PIC16C64

PIC16C64 Rev. A Silicon Errata Sheet

Clarifications/Corrections to the Data Sheet:

FIGURE 1: WRITES TO TIMER1 (EXTERNAL CLOCK / OSCILLATOR MODE)

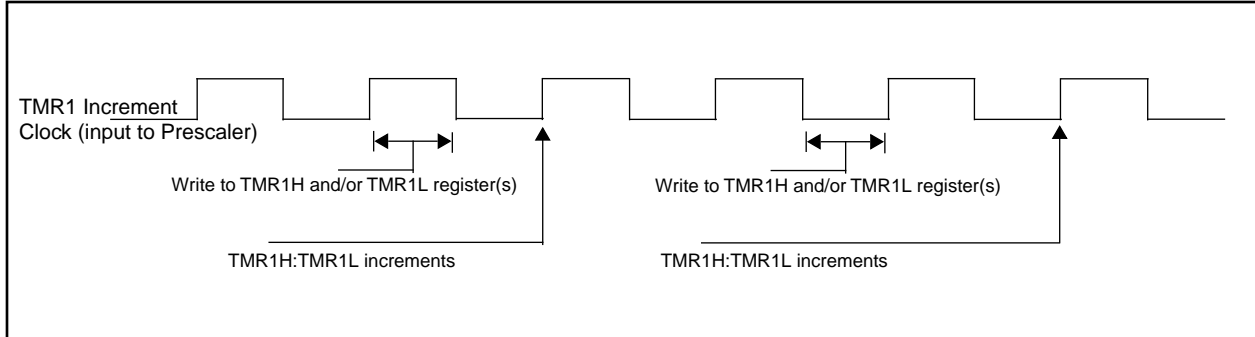
- a) The operation of Timer1 needs some clarification when the timer registers are written when the TMR1ON bit is set.

The internal clock signal that is the input to the TMR1 prescaler affects the incrementing of Timer1 (TMR1H:TMR1L registers and the Timer1 prescaler). When the Timer1 registers are NOT written, the Timer1 will increment on the rising edge of the TMR1 increment clock.

When the TMR1H and/or TMR1L registers are written while this clock is high, TMR1 will increment on the next rising edge of this clock.

When the TMR1H and/or TMR1L registers are written while this clock is low, TMR1 will not increment on the next rising edge of this clock, but must first have a falling clock and then the rising clock for TMR1 to increment.

Figure 1 shows the two cases of writes to the TMR1H and/or TMR1L registers. Due to the V_{IH} and V_{IL} thresholds on the oscillator/clock pins, external

Timer1 oscillator components, and external clock frequency, the Timer1 increment clock may not be of a 50% duty cycle.

The TMR1 increment clock is out of phase of the T1OSO/T1CKI pin by a small propagation delay.
